Planning Commission Issues Report

Subject: Change of Zoning Issues Report

Meeting Date: October 14, 2013

Petition: P.Z. 09 & 10-2013 Schoettler Grove (2349 Schoettler Rd.)

SHEET NO.:
C1.2

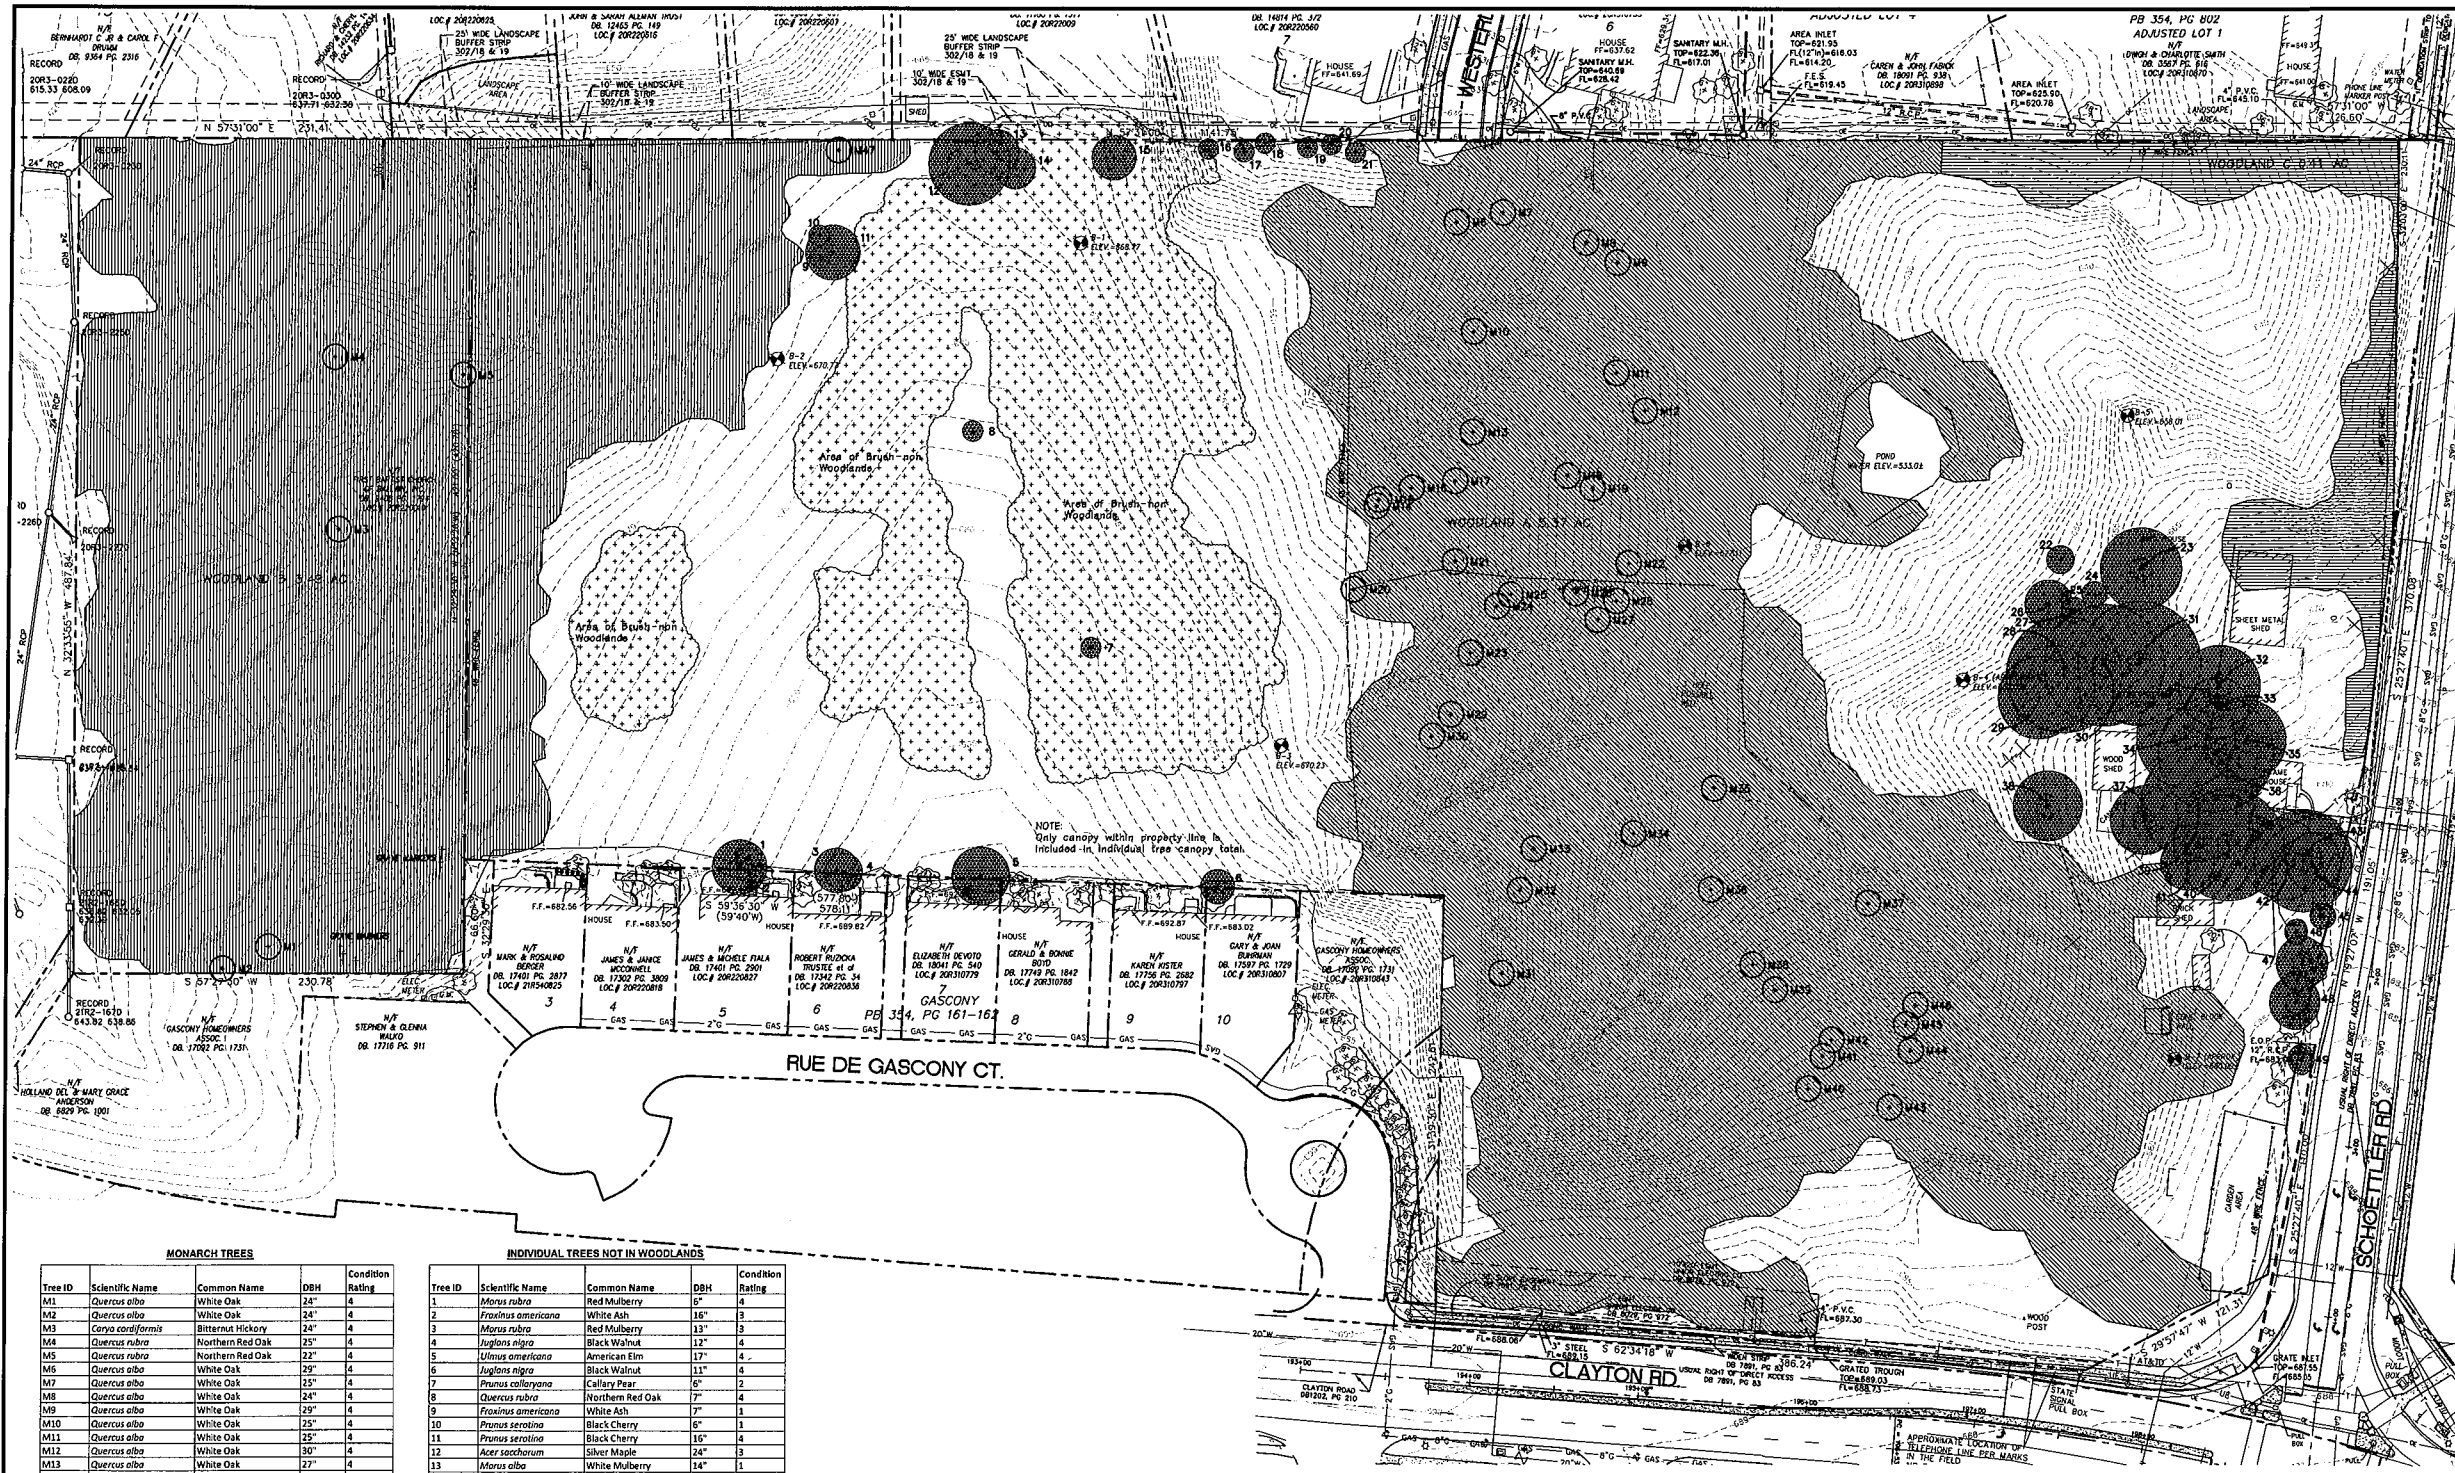
Following the Public Hearing, the petitioner has provided an amended Preliminary Plan which redesigned the site to address issues identified the Public Hearing and by Staff. This new Preliminary Plan removed the loop street on the western section of the plan, provided additional right-of-way dedication along Schoettler for future road improvements, and provided more detail on the preservation area around the existing cemetery on-site on the western section.

- **Buffering issues adjacent to this development; specifically concerns with loss of heavy vegetation/landscaping/berming and vehicular headlight glare from the proposed street layout.**
As discussed under the Analysis Section, a new Preliminary Plan has been proposed by the Developer to address the multiple concerns of this development. With the new proposed layout (removing the internal loop street on the western half of the site), additional buffering can be provided which as a by-product limits grading activity near the borders of the proposed development. Additionally, this re-design removed the opportunity for headlight glare to adjacent properties. With the redesign, larger landscape buffers within proposes common are along the north and south boundaries of the development assist to maintain the existing landscape along the boundaries.

2. Buffering issues adjacent to this development were discussed, specifically concerns with loss of heavy vegetation/landscaping/berming and vehicular headlight glare from proposed street layout (streets near property lines).

The Preliminary Plan (the "Plan") has been revised to (a) move streets away from property lines so that the rear yards of the homes in the development back to rear yards of Gascony and Westerly; (b) provide greater non-disturbance limits and larger lots along the North and South boundaries of the development West of Westerly Court; (c) create greater separation of new homes from existing homes in Gascony and Westerly; and (d) reconfigure the streets so that headlights from motor vehicles in the development do not shine North or South, West of Westerly Court, when motor vehicles are travelling on the street at night.
